<b>Bulletin Number:</b>	TSB 0031-01
<b>Release Date:</b>	7-May-2024
<b>Effective Date:</b>	7-May-2024
<b>Supersedes:</b>	none
<b>Completion Date:</b>	26-May-2025

# Service Bulletin

<b>Manufacturer:</b>	Head Rush Technologies
<b>Affected Production Dates:</b>	1-Nov-2022 through 26-Feb-2024
<b>Product Names:</b>	TRUBLUE iQ LT (12.5m); TRUBLUE iQ XL (20m); TRUBLUE iQ+ LT (12.5m); TRUBLUE iQ+ XL (20m)
<b>Affected Serial Numbers:</b>	iQ0014492 through iQ0036407 iQXL01283 through iQXL02678 iQP00110 through iQP00161 iQP000164 through iQP000356 iQXLP0104 through iQXLP0182
<b>Model Numbers:</b>	TBiQ-LT; TBiQ-XL; TBiQ+LT; TBiQ+XL

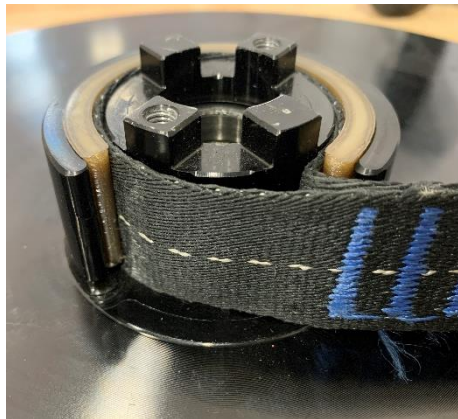
10. Align the Arbor Support Component with the ends of the Planet Carrier Arbor. Rotate the Short Webbing Loop as far to the right as possible as shown in the image below.

Full Height Arbor Support Component

Half Height Arbor Support Component

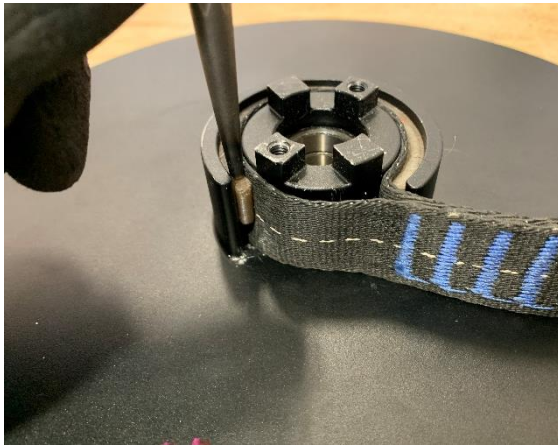
11. Press the appropriate Arbor Support Component into place as shown in the image below. Ensure the top of the Arbor Support Component is flush with the top of the Planet Carrier Arbor.

- a. The Arbor Support component is tapered. Install the Arbor Support component with the tapered side facing down.
